Amendments to the Drawings:

ARGUMENTS/REMARKS

Fig. 2B

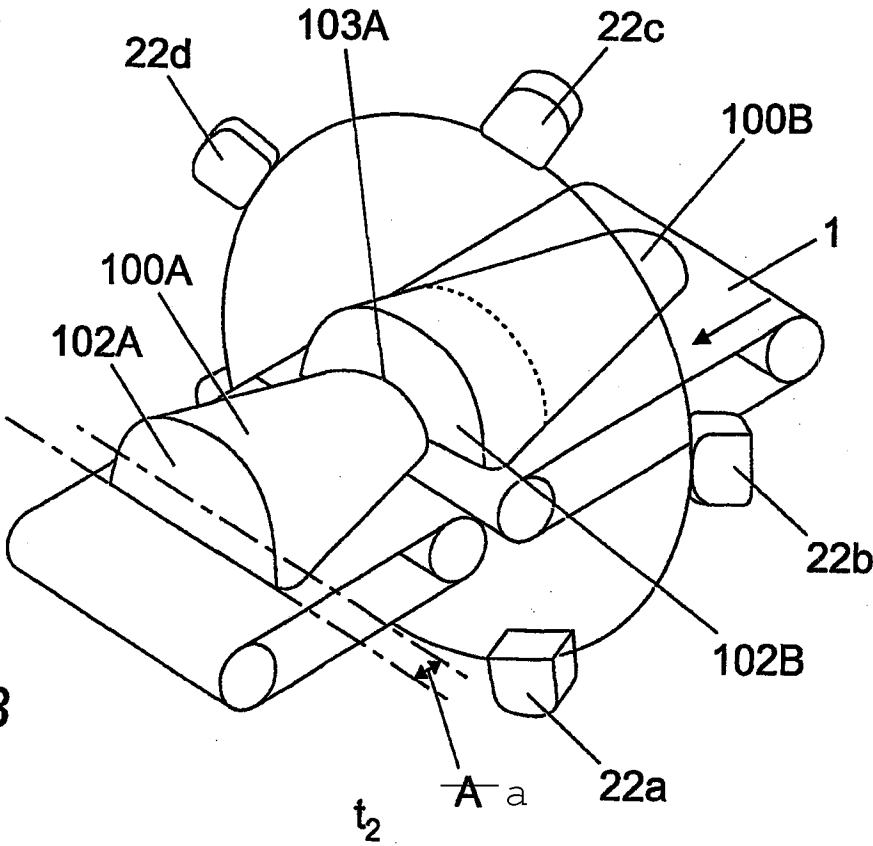
The attached sheets 1-5 of replacement drawings reflected by Figs. 1, 2A, 2B, and 3-7 include changes to Figure 2B, where the reference “A” was changed to an “a” so that it now conforms to the description. Figure 3 has been amended to remove the references “103B” and “122”, as they are not used in the description. In figure 5 the reference “122” has been removed. A new drawing is provided as figure 7 that is a copy of figure 1, but with transition markers shown as described in the specification utilizing unused reference “5” for the transition markers.

In the specification, two paragraphs have been amended to add missing reference numbers. In the replacement drawings, various changes were provided that include changes to Figure 2B, where the reference “A” was changed to an “a” so that it now conforms to the description. Figure 3 has been amended to remove the references “103B” and “122”, as they are not used in the description. In figure 5, the reference “122” has been removed. A new drawing is provided as Figure 7 that is a copy of figure 1, but with transition markers shown as described in the specification paragraph beginning at line 30 on page 13, utilizing unused reference “5” for the transition markers provided in the figure. The changes to the drawings and specification are deemed to address the Examiner’s objections to the drawings, and thus it is recommended that the rejection be withdrawn.
